**SOUTH DAKOTA
WATER PERMIT NO. 2451-2**

Ken Fisher Wetland Creation Project Tripp County, South Dakota

REPORT ON
WATER PERMIT APPLICATION NO. 2451-2

**RECOMMENDATION OF CHIEF ENGINEER FOR WATER PERMIT
APPLICATION NO. 2451-2, Kenneth L. Fisher**

TYPICAL CROSS SECTION OF DAM

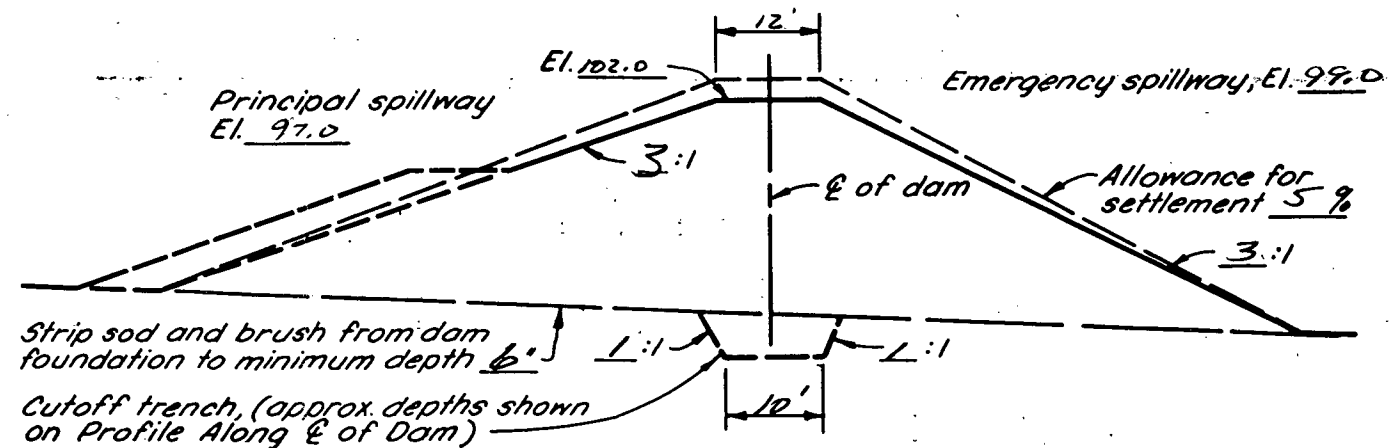
1. Topo Map - OK
2. Dam Axis - OK
3. Dam Max X-Sec. - OK
4. Area Capacity - OK
5. Outlet Details - OK
6. Spillway Rating - OK
7. Spillway Details - OK
8. Specs - STD NRCS - OK
9. EPP - N/A Cat. 3 - OK

SKETCH PLAN OF DAM AND RESERVOIR AREA

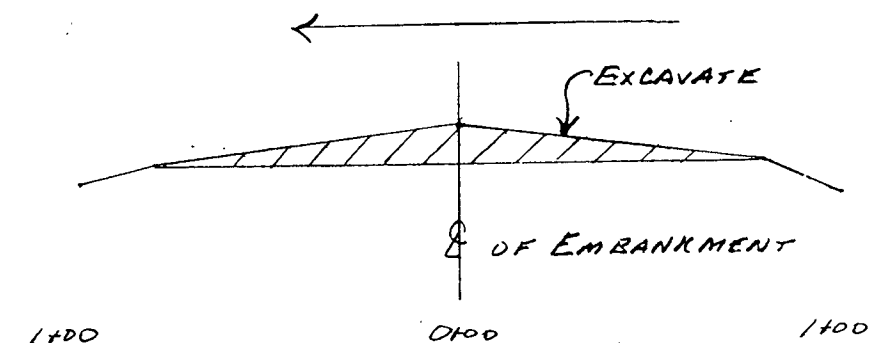
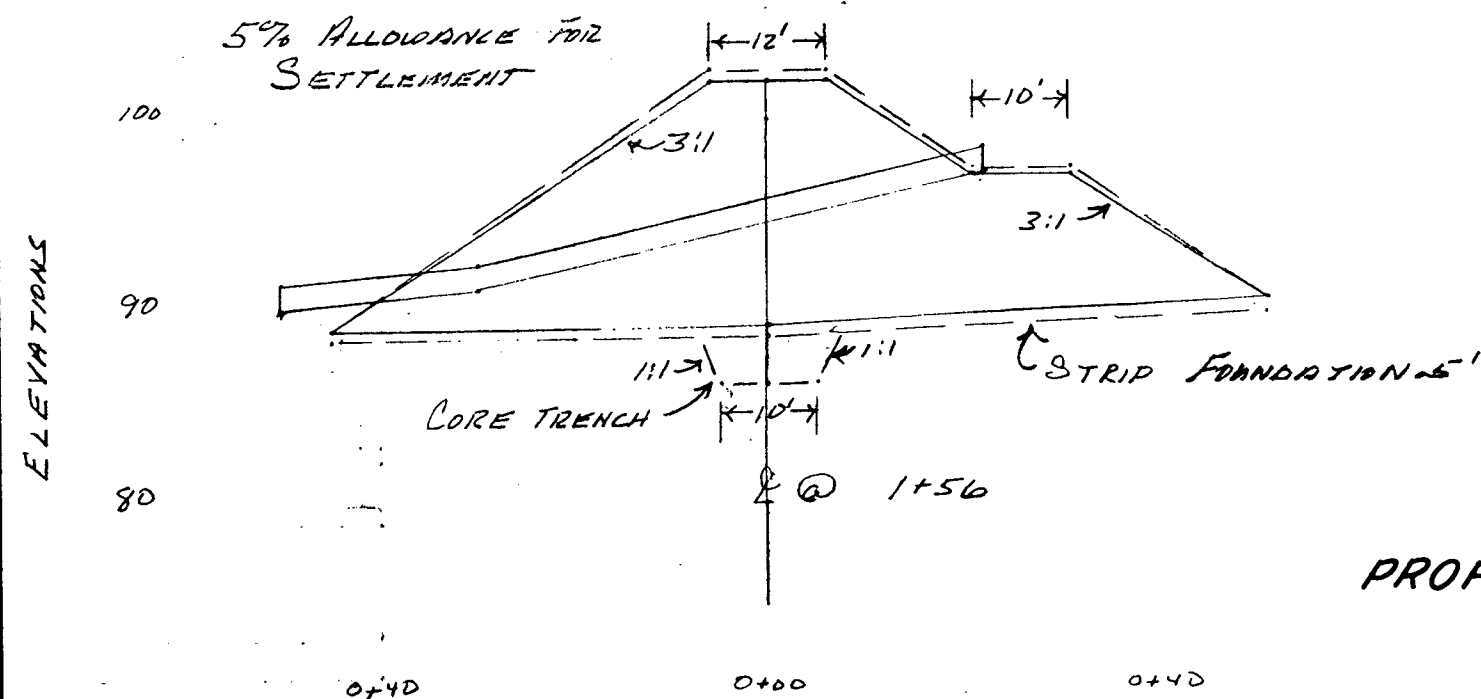
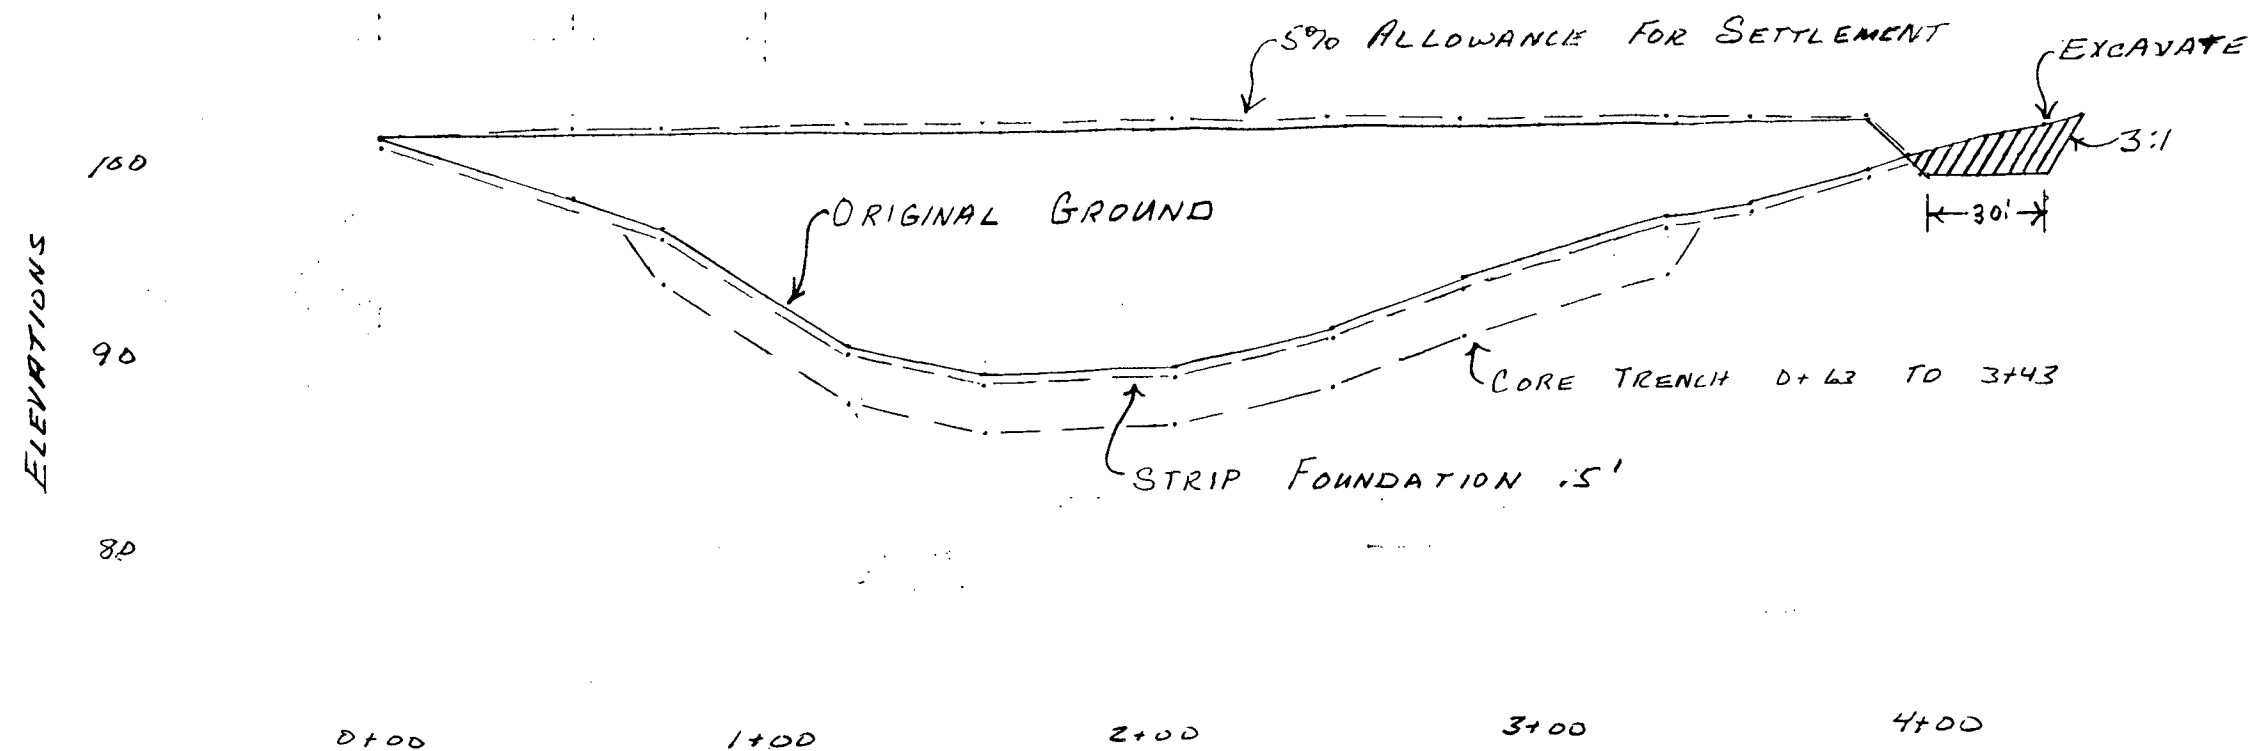
As I discussed with you on the phone, plans and specifications for the proposed dam must be submitted for approval. An engineer must sign these plans. When NRCS designs a dam they also provide a classification of the dam according to the dam safety rules.

Finally, the map showing the location of the dam that you submitted needs to be signed by a licensed engineer, licensed land surveyor or a government employees that prepares maps as a normal part of their job. I am including a copy of your submitted map that can be used if NRCS does not plan to include a map with the plans and specifications. Generally, NRCS includes such a map with their submittal of plans and specifications. However, if you re-submit the map it will need to be properly signed.
